RANCOCAS VALLEY REGIONAL SCHOOL DISTRICT
RANCOCAS VALLEY REGIONAL HIGH SCHOOL SECURITY ENTRANCE
AND MAIN OFFICE RENOVATIONS
Addendum #1
March 14, 2019

Bid Package Clarification and Changes

ADM-01

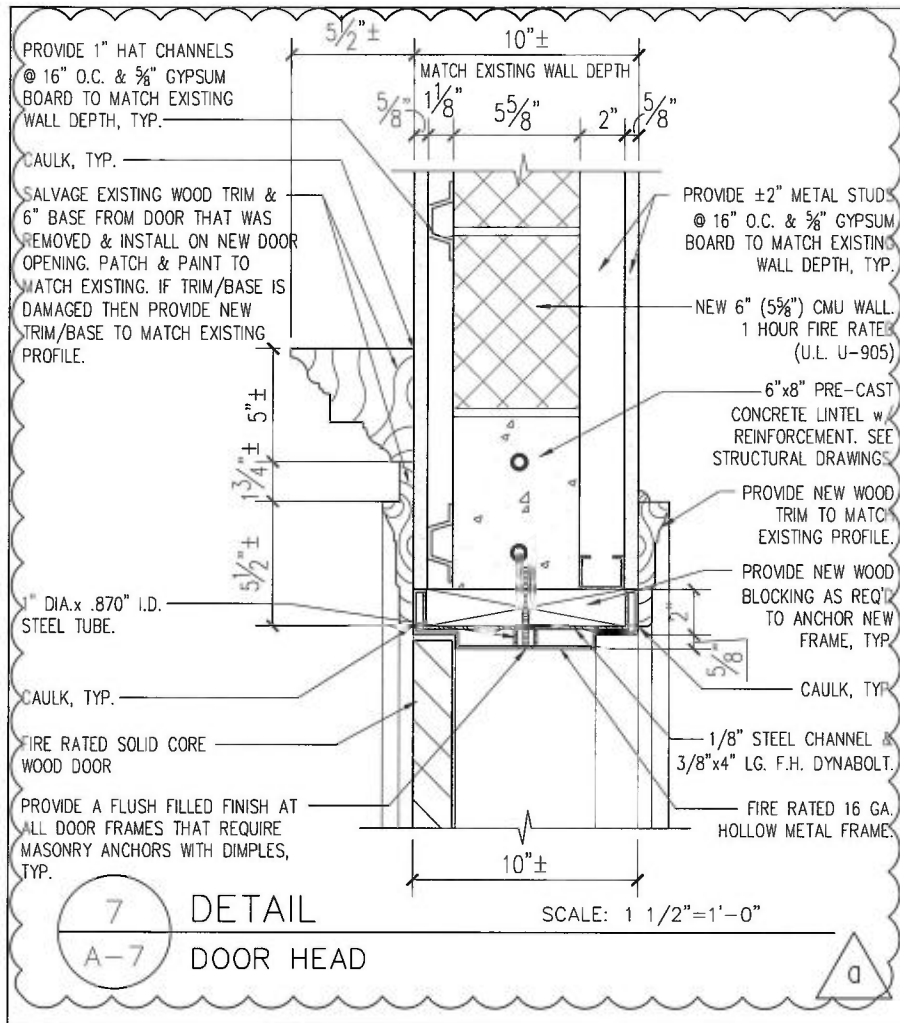
18. On Drawing A-2; Details 2/A-2, 3/A-2 & 4/A-2: Revise the wall type shown on these window details to include metal furring and GWB board on both sides of the CMU partition. Refer to sketches ADM-01 & ADM-02 (attached herein) for similar wall construction. As clarification, the new transaction windows will be installed into new and existing partition walls. Adjust the window installation to accommodate both conditions accordingly.

22. On Drawing A-7; Detail 7/A-7: Revise this detail as indicated in the **attached sketch ADM-01**. Revisions include reducing the CMU wall thickness and adding GWB and furring channels.

ADM-02

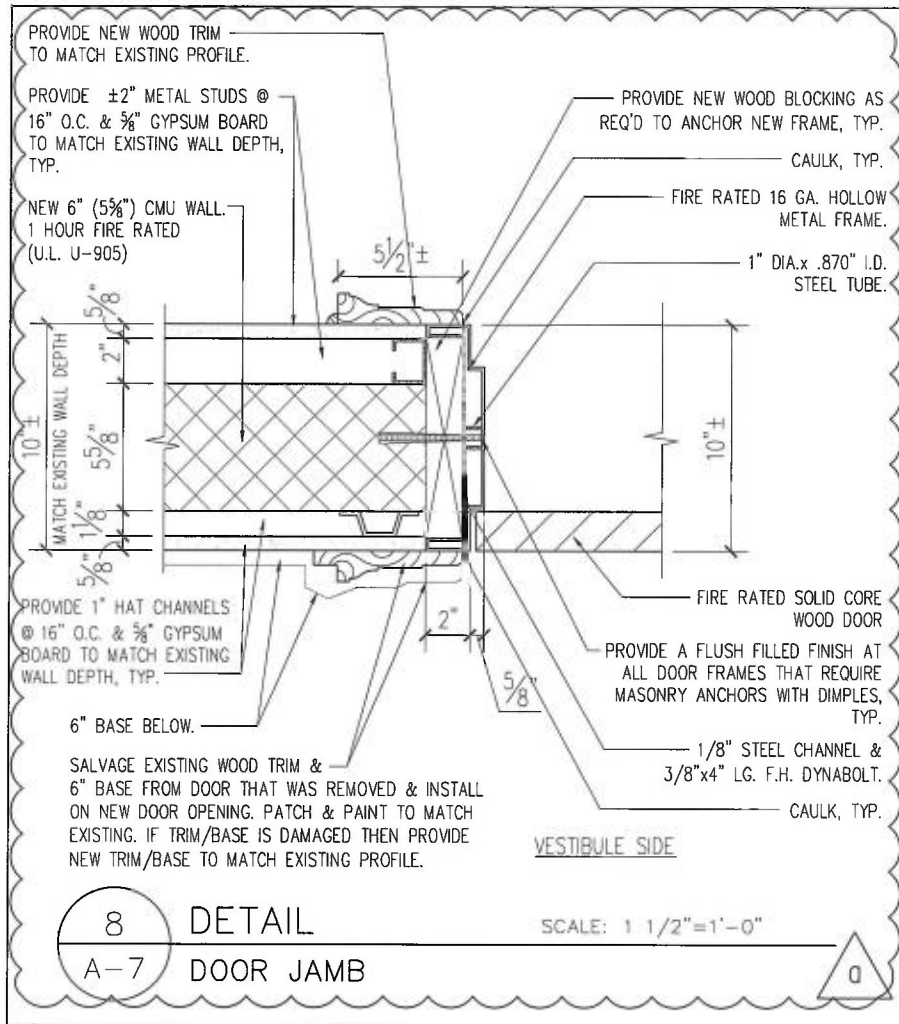
23. On Drawing A-7; Detail 8/A-7: Revise this detail as indicated in the **attached sketch ADM-02**. Revisions include reducing the CMU wall thickness and adding GWB and furring channels.
